PGRR144: ERCOT Responses and Additional Revisions

Dynamic Studies - Grid Stability Analysis, ERCOT

April 2026

Updated Large Load Voltage Ride-Through (VRT) Test Curve

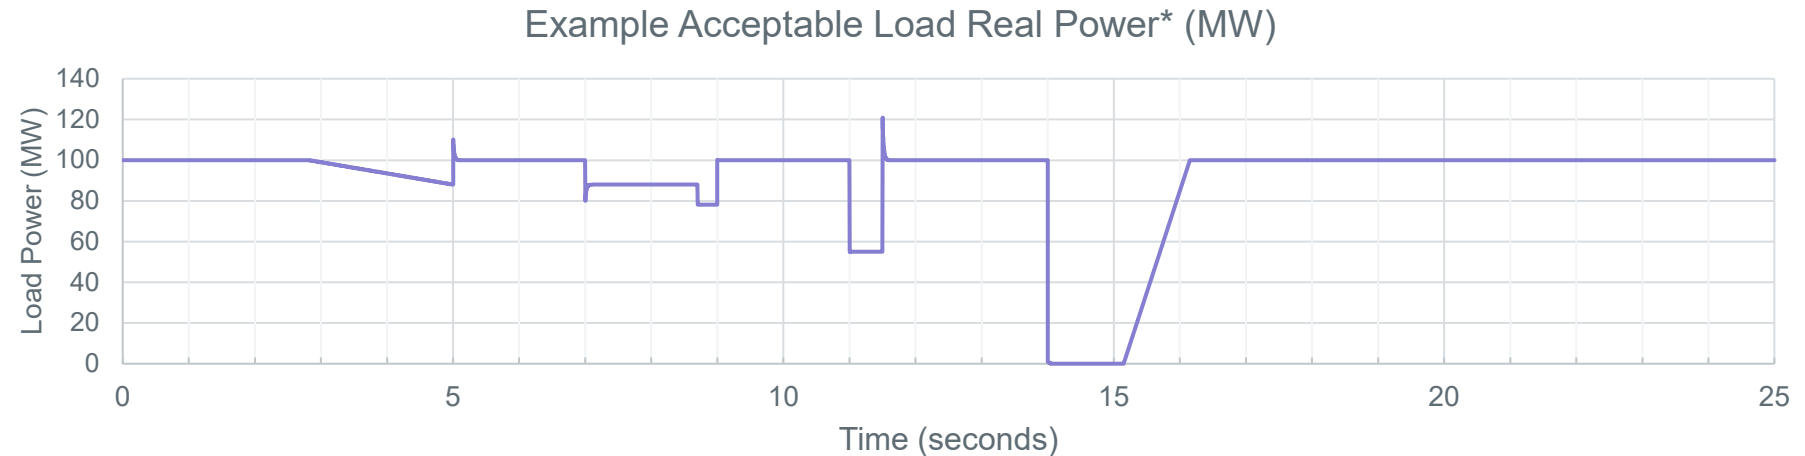
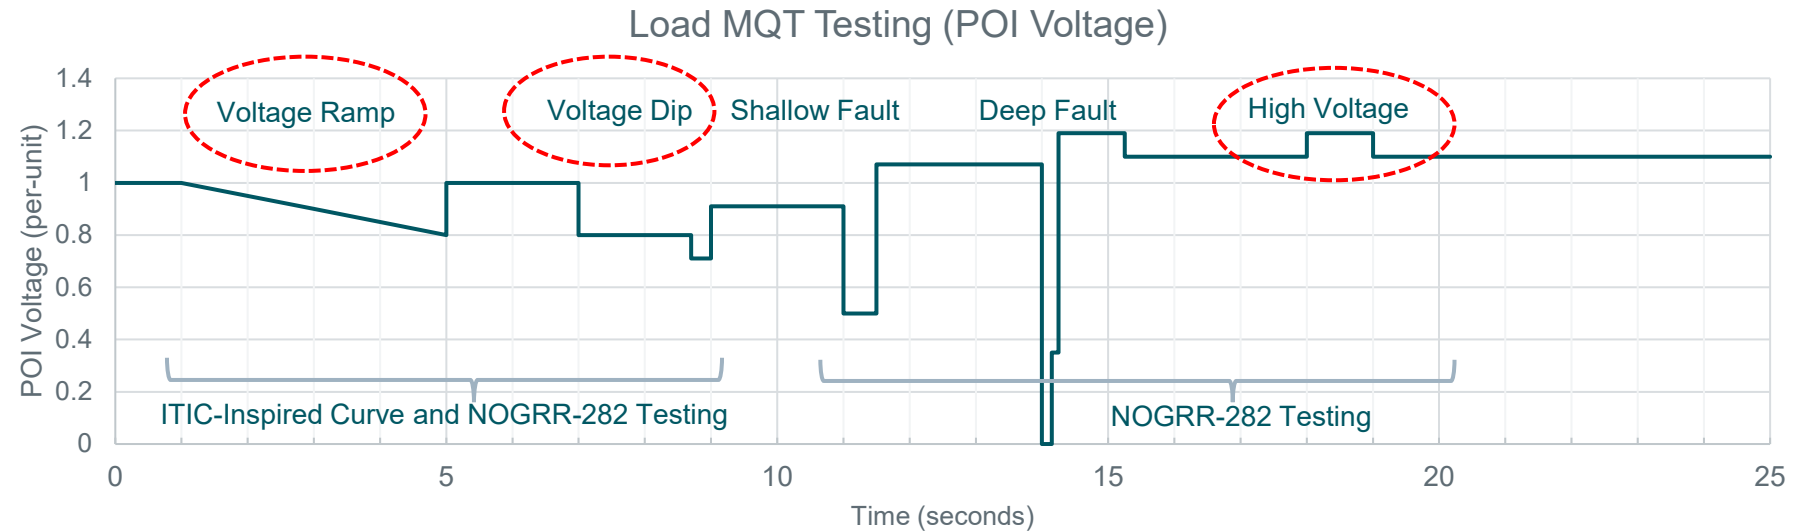
- DCC requested ERCOT's confirmation that model quality tests will be evaluated based on NOGRR 282 requirements rather than exact matching of the illustrative example curves shown in the proposed DWG Procedure Manual 3.1.5.16

Based on ERCOT internal feedback, minor updates were made to the VRT test curve proposed in the DWG procedure manual:

- Swapped the order of the initial small voltage dip and voltage ramp in the previous test curve that ERCOT shared at the [March LLWG meeting](#)
- Added the high voltage ride through test at the end in order to assess the condition after reconnection complete.

- ERCOT confirms that model review for LELs will be based on the NOG Section 2.15 requirements. The curve introduced in the DWG Procedure Manual is intended as illustrative guidance
